CITY OF MANASSAS PARK
Public Hearing
Planning Commission
Wednesday, May 10, 2023
7:00 PM

Staff Report

Rezoning, RZ#22-03, Downtown Development Phase IV, Artena Park
Waivers, WAI#22-03A-G and Public Facilities Manual Waivers, PFW#22-03A-D

Applicant: Artena, LLC

CONSOLIDATED LOT TOTAL: 7.82 ACRES
CONVEY DRIVE INGRESS/EGRESS CONVERSION TO ROW DEDICATION: 0.41 ACRES
EPD LOT DEVELOPMENT AREA: 7.41 ACRES

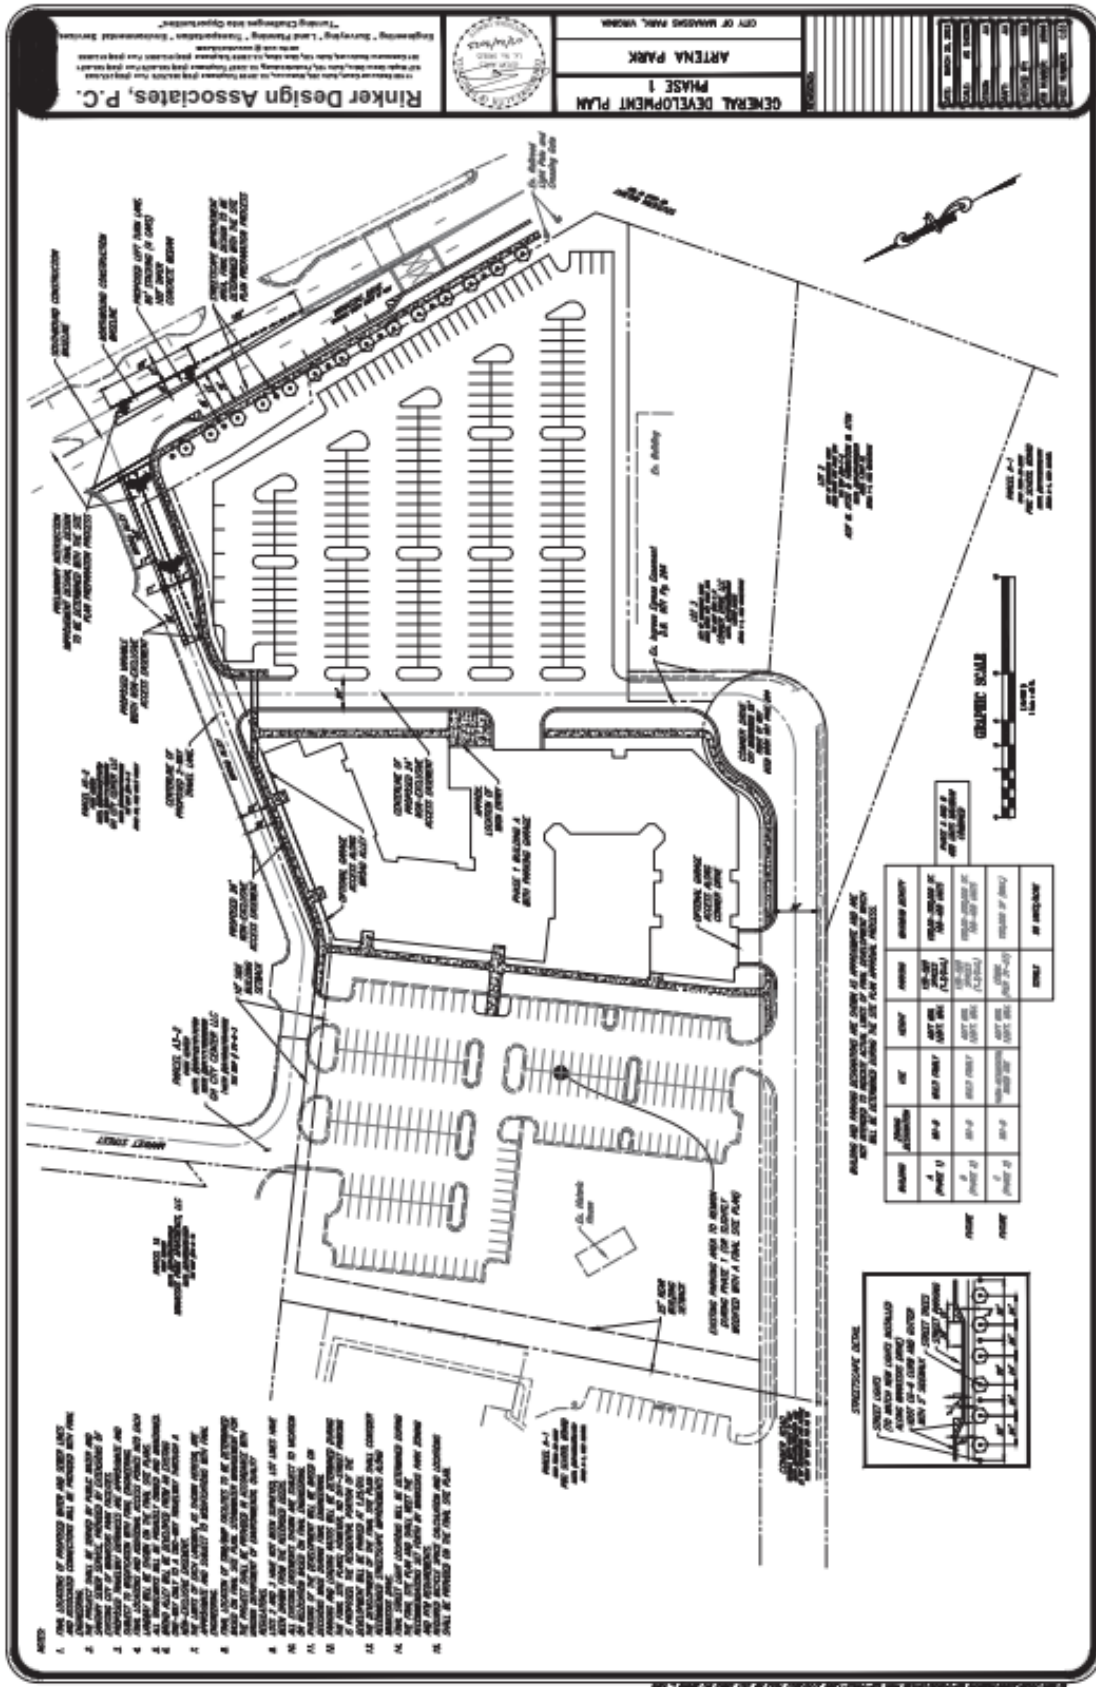
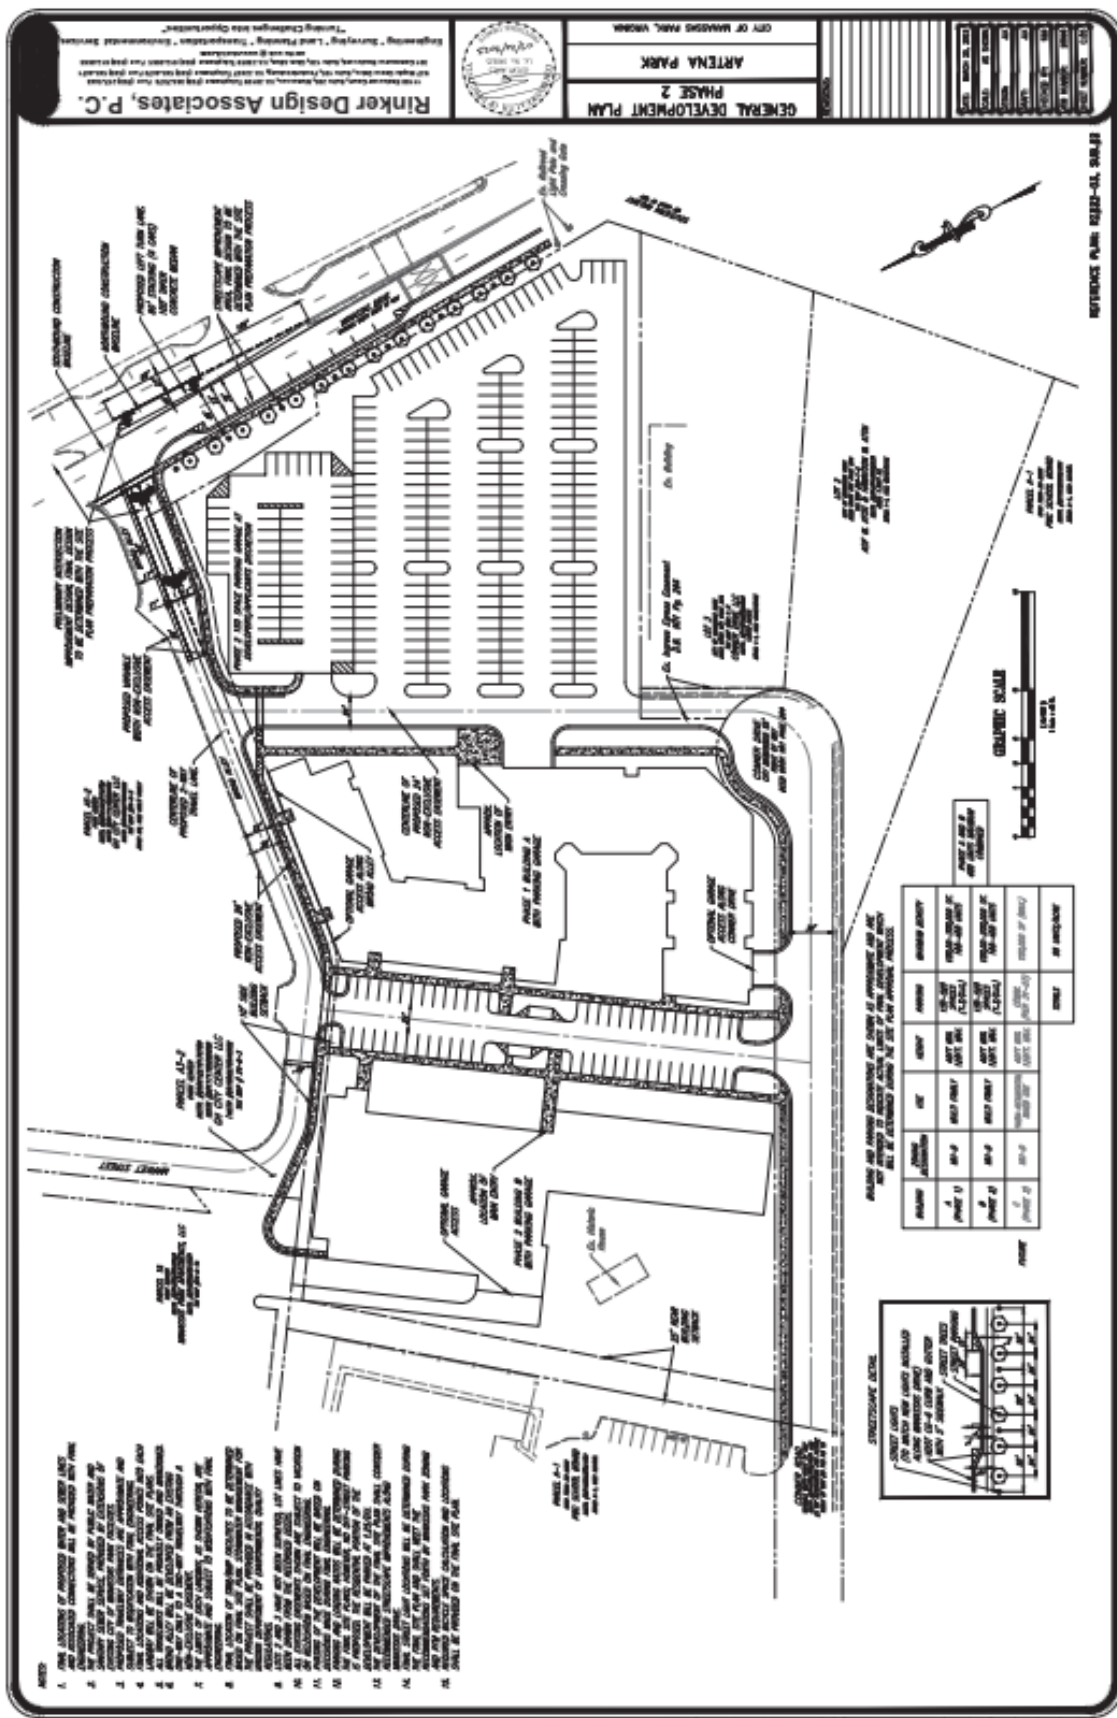
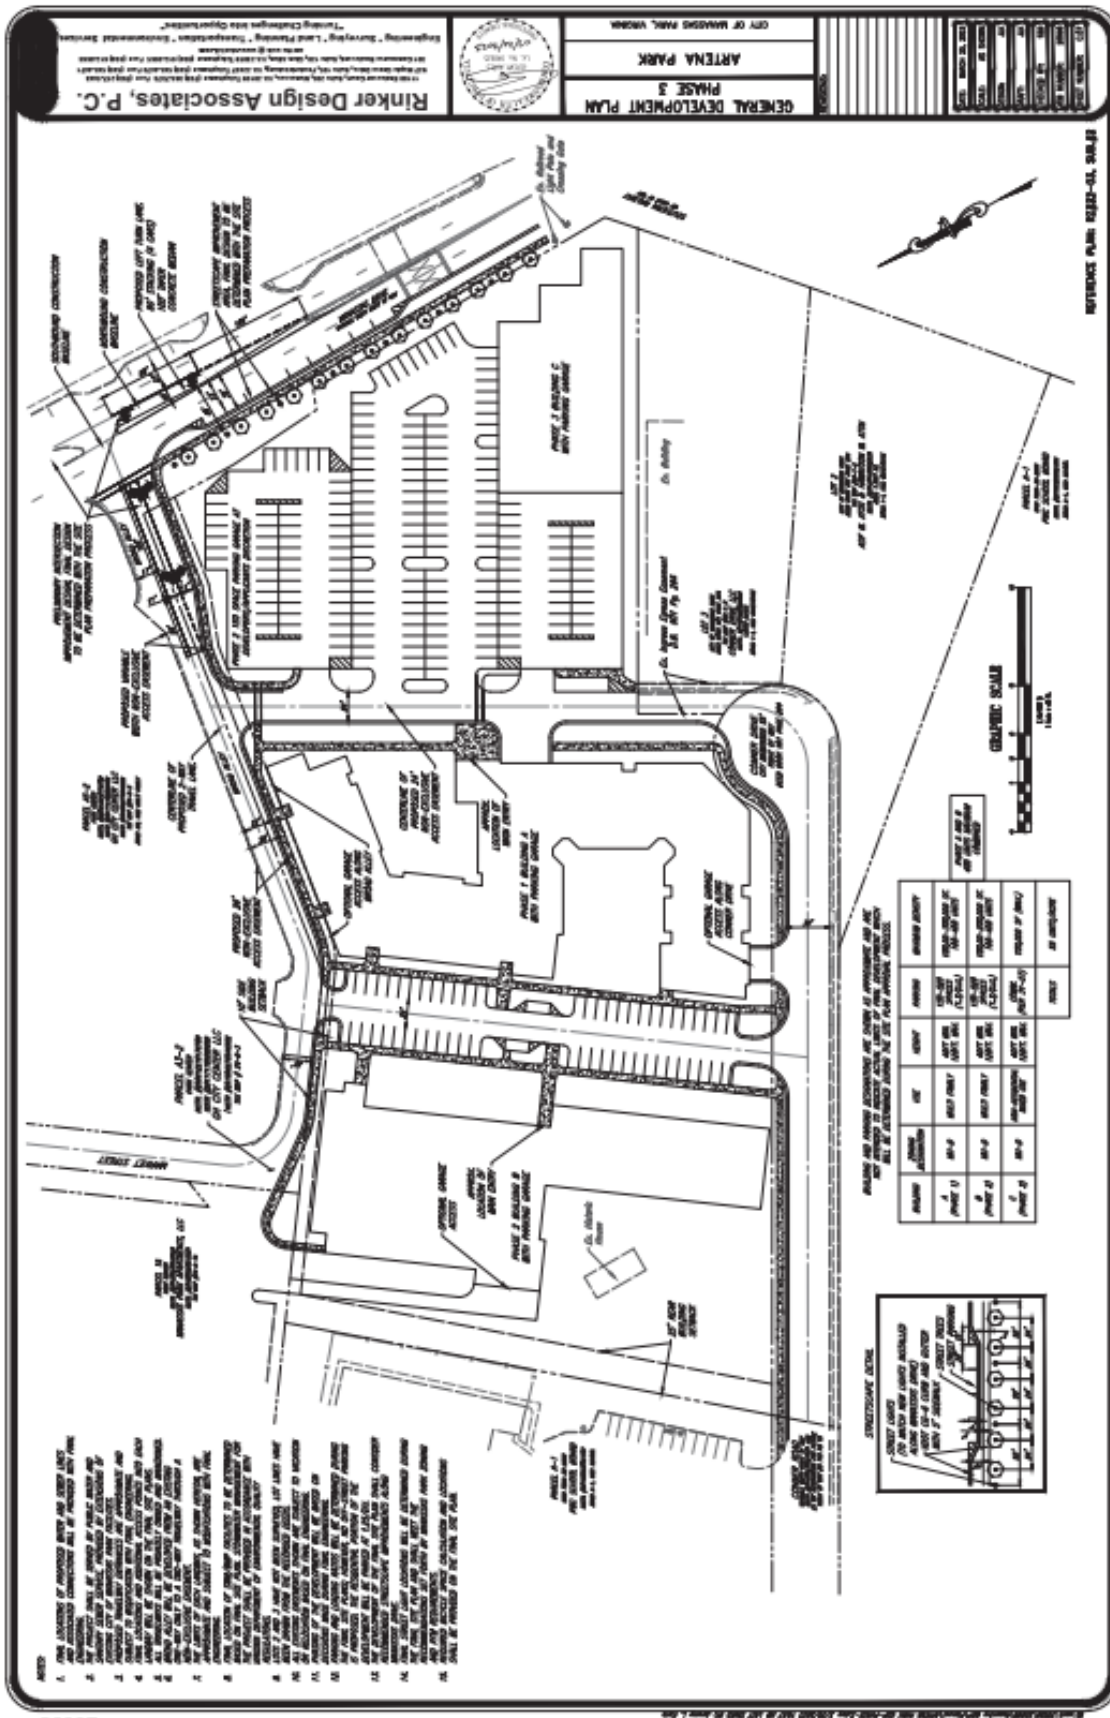
Parking: Parking for the development will include surface lots, podium and structured parking for the apartment buildings, a parking garage for the proposed 100,000 square foot commercial building, and a dedicated 150-space lot or garage for the mixed-use development to the north of the site, Parq 170 at City Center. The parking requirements for multi-family dwellings are 1.75 spaces per unit plus 1 space per every 10 units. The applicant is seeking a waiver to reduce the parking requirement for the apartment buildings to 1.3 spaces per unit. See the Waivers & Modifications section for more details on the parking reduction.

Loading: There are no loading spaces shown on the GDP. Loading requirements are found under Sec. 31-28 of the Zoning Ordinance. Based on these provisions, loading spaces are not required for multifamily dwellings. However, staff recommends that at least one loading space be provided for each apartment building. Based on the GDP, the apartment buildings are going to be a maximum of 120 feet in height or approximately 10 stories. A dedicated space or loading dock interior to the building should be provided to assist with large deliveries and facilitate the moving process for tenants. Having such a loading area would alleviate the blocking of parking spaces and drive aisles from moving and large delivery trucks.

Commercial uses do require dedicated loading spaces at 1 space per 10,000 square feet of floor area. Based on this requirement, the commercial building would need 10 loading spaces. Clearly, ten loading spaces is excessive, especially for one building. The applicant is also seeking a reduction to the loading space requirements. Sec. 31-28(a)(2) of the Zoning Ordinance does allow the number of loading spaces to be reduced if it can serve two or more uses, provided the City can be assured of the permanent availability of the loading spaces. The applicant is requesting only two loading spaces be required. Although not shown in any of the submitted plans or illustrations, the applicant has stated the loading areas will be internal to the buildings, subject to final design. Furthermore, the applicant anticipates each apartment building will have at least one interior loading dock. Staff supports loading docks for the apartments. For the commercial building, staff believes two loading spaces will provide sufficient flexibility in meeting the delivery needs of all tenants. If necessary, a delivery schedule can be created, so deliveries can be appropriately timed. To ensure the permanent availability of the loading spaces and provide efficient traffic circulation on site, staff will accept the reduction only if they are interior loading spaces. The actual number of loading spaces can be determined at the site plan stage.

Parking Lot Landscaping Waivers (WAI#22-03D & WAI#22-03F): The requested waivers modify the interior parking lot landscaping requirements in favor of the parking lot landscaping shown on the GDP. To achieve the vision for the downtown, the required 9 foot by 18 foot landscaping bays and the 8 square feet of open space per parking space located no more than 125 feet from any landscaped area need to be modified.

The requested waivers are due to the compact, urban nature of the project. Given the design and layout of the parking areas shown on the GDP, meeting the parking lot landscaping requirements would be detrimental to the layout and design of the site. These requirements are tailored towards low density, single lot developments and shopping centers. The requested modifications maximize the efficiency of the proposed parking areas by providing landscaping on the periphery. For these reasons, staff is supportive of the parking lot landscaping waivers.

The proposed development has been designed using urban street standards. The City's PFM is predicated on suburban development specifications and it does not address urban street design. Therefore, the private street modifications are necessary for creating a successful development and a vibrant downtown. Reducing the required 30 foot private street width may be appropriate for an urban, compact development. Like the Phase III Downtown Development, the Fire Marshal recommends street widths of no less than 26 feet to allow sufficient room for fire trucks to access the buildings adequately during an emergency. Therefore, staff recommends the private street width be reduced to no less than 26 feet, not 24 as requested by the applicant. As provided in the proffers, the fire lanes will be designed at the time of site plan submission, so the private street width may be increased. Staff recommends that the waiver approval limits private street width to a minimum 26 feet.

1. Provides a design of the Conner Drive frontage using VDOT Urban Street standards at the time of the Phase II site plan submission.
2. Removes the existing crosswalk on Manassas Drive immediately south of Broad Alley.
3. Clarifies that the existing NOVEC streetlights will be removed and all existing utilities will be placed underground.

For the requested waivers, staff recommends approval of waivers, WAI#22-03A, D, E, and F and PFM#B-D. Staff's recommendations for the remaining waivers are as follows:

Waiver, WAI#22-03B: Grant approval of this waiver subject to the submission of architectural elevations by the applicant for the stand-alone parking structure as well as the commercial building and associated parking garage with final review and approval by the Zoning Administrator to ensure the height and bulk of these structures are in keeping with the downtown architecture and proposed development.

Waiver, WAI#22-03C: Grant approval of this waiver subject to submission of an open space and recreation plan by the applicant that shows plantings, benches, and an outdoor pool for each apartment building with final review and approval by the Zoning Administrator.

Waiver, WAI#22-03G: Grant approval of this waiver subject to submission of a landscaping and screening plan by the applicant that shows vegetative screening for the abutting industrial property and screening consisting of landscaping and an opaque fence or structure shielding the industrial properties at street level when viewed from Manassas Drive with final review and approval by the Zoning Administrator.

Waiver, PFW#22-03A: Grant approval of this waiver provided the width of private streets is no less than 26 feet.
